Version 2

Safety Recall: 2017–20 NSX Fuel Pump Motor

Supersedes 24-010, dated January 17, 2024 to revise the information highlighted in **yellow**.

Under REPAIR PROCEDURE, Step 15 has been revised.

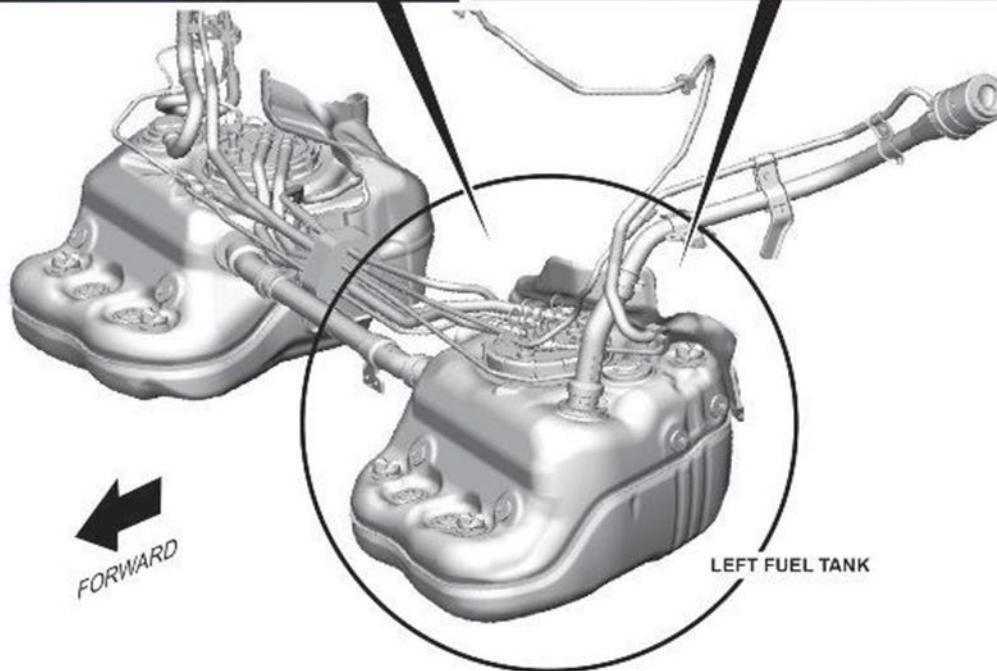
15. On the driver's side rear wheel well, do the following:

- Disconnect the fuel tank unit connectors.
